**Re: Comment Letter**  
**OPA & ZBLA Applications – Files D01-21005 & D02-21008**  
**1000 Elgin Mills Road East – Elgin House Properties Limited**

#### **Comments on Files D01-21005 & D02-21008**

Site Plan

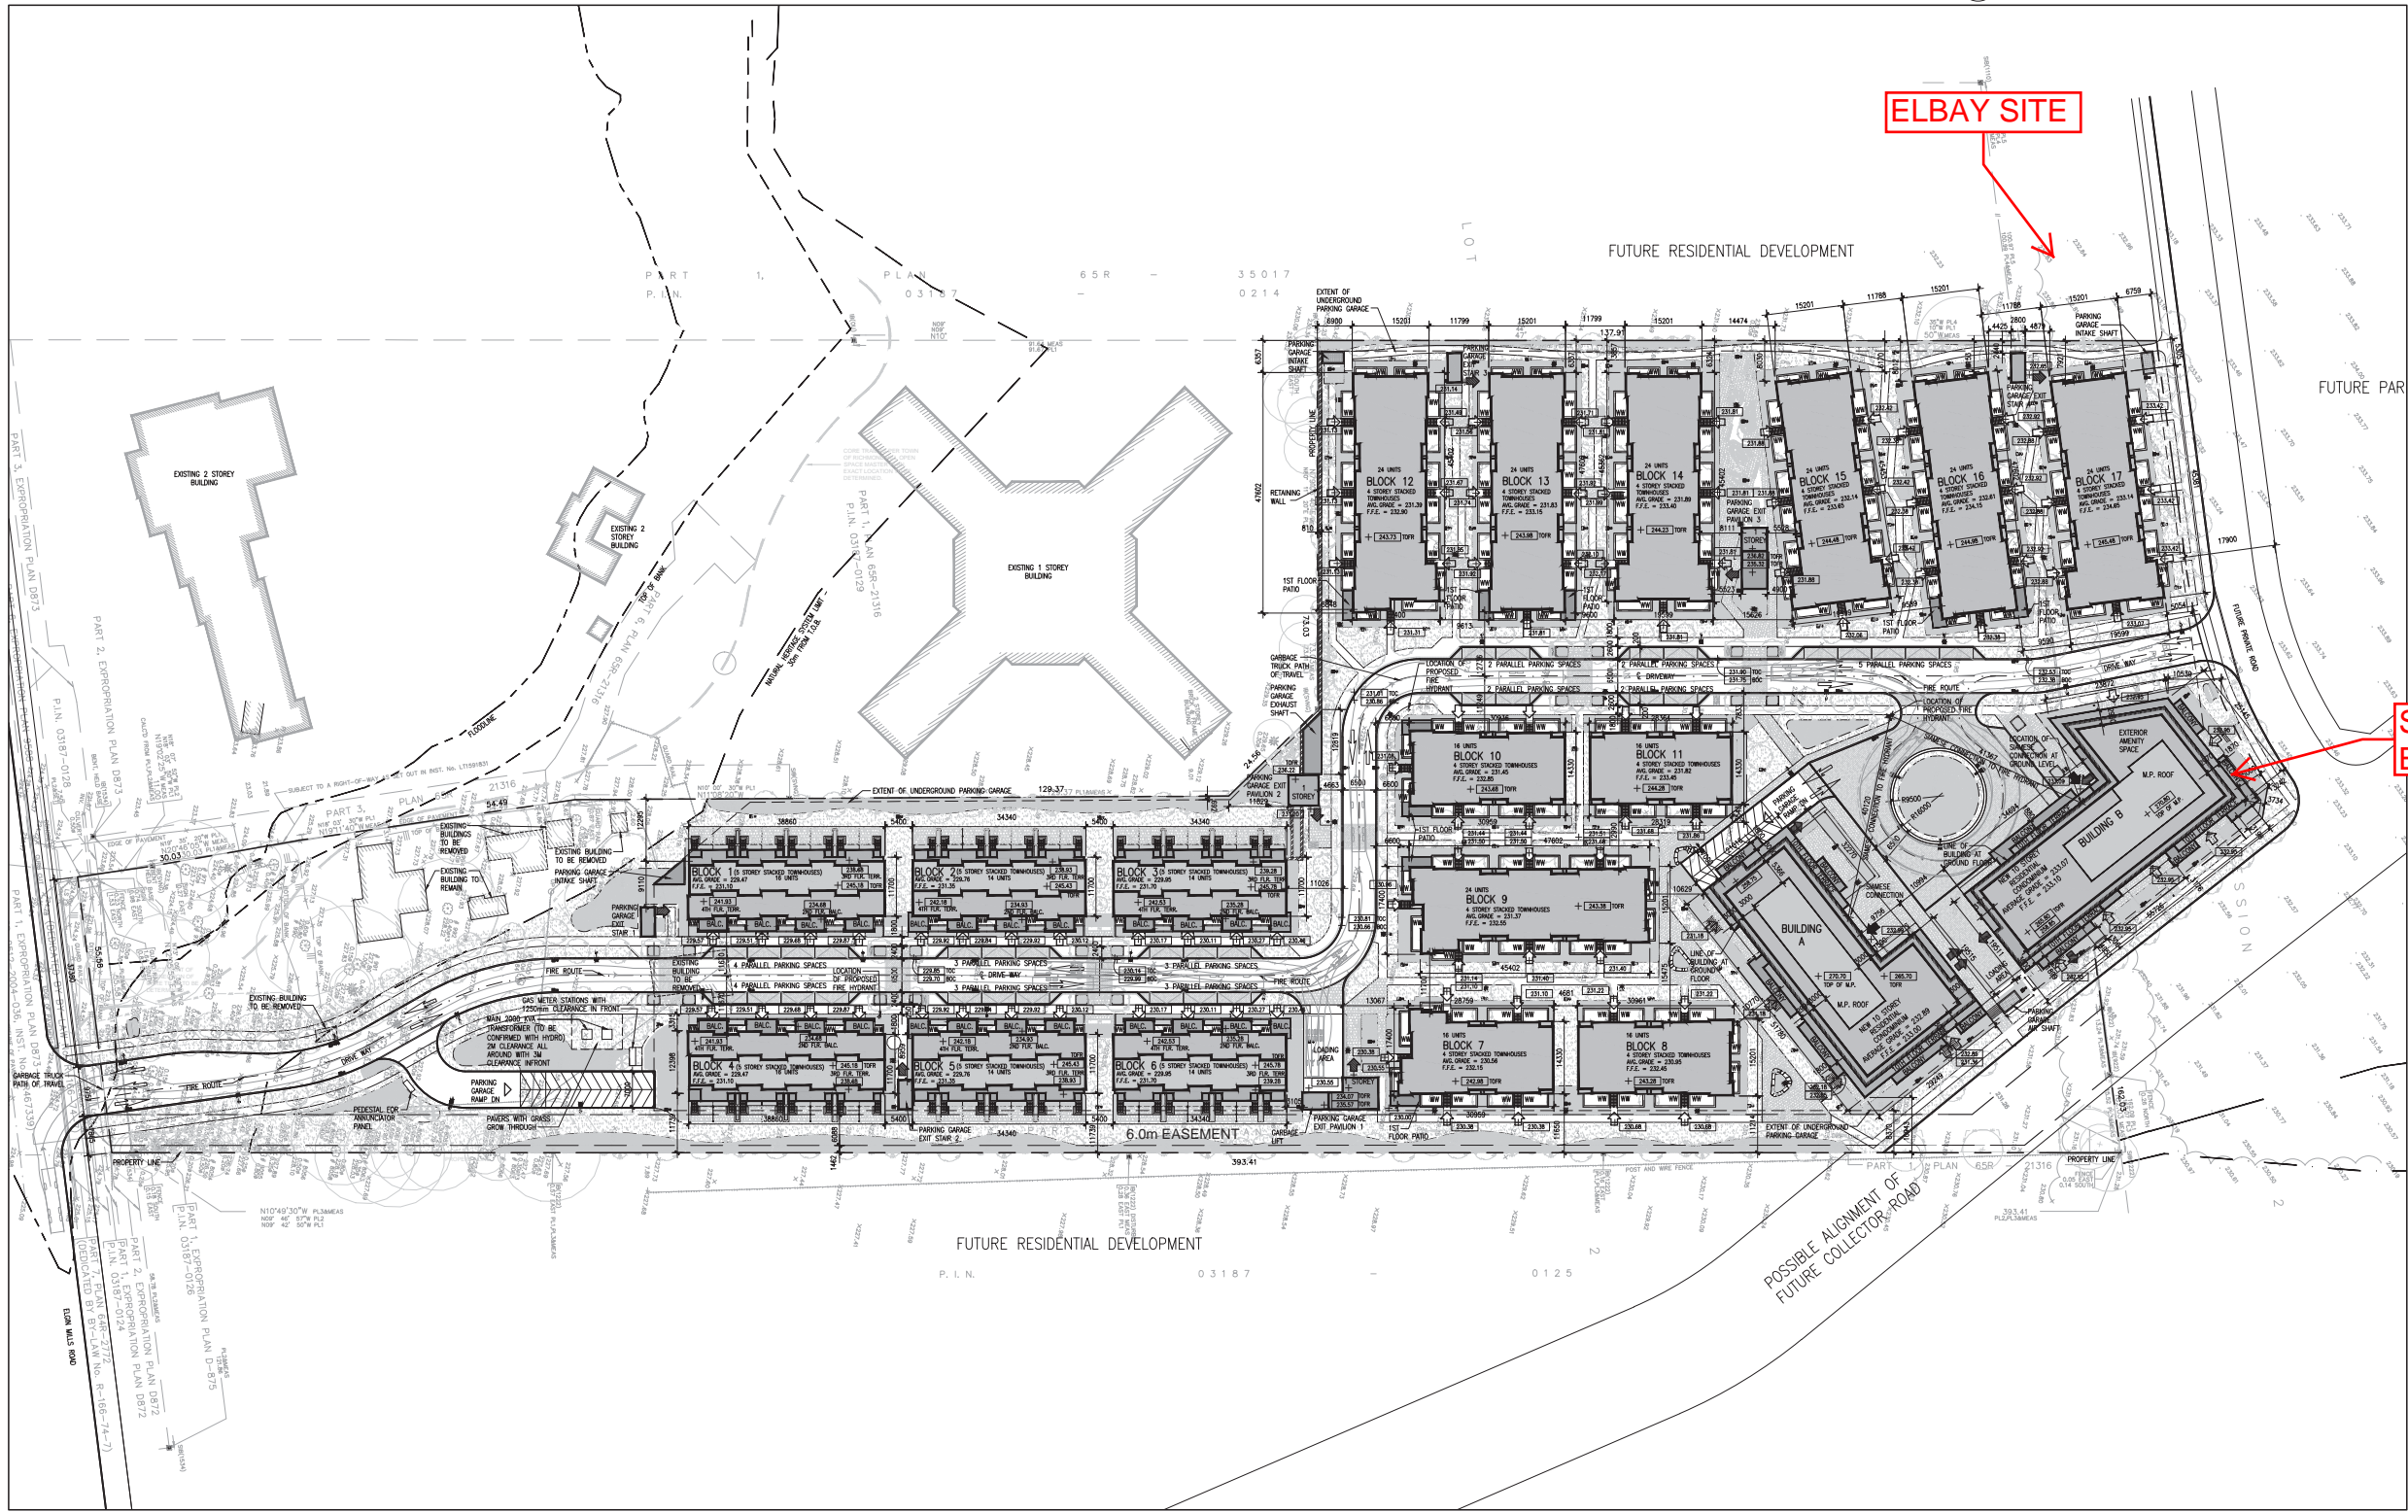
Elgin House originally submitted OPA, ZBLA and Site Plan applications (Files D01-15007, D02-15036 and D06-15079) in 2015. The first architectural set of drawings Elbay was provided from Elgin House was from September 2015, which provided for 4 storey townhouse dwellings located along the western limit of the Subject Site. This version of the Site Plan provided for adequate transitioning to the Elbay lands, as there was a stepping up of building massing along the Elgin House site – see **Attachment 1**.
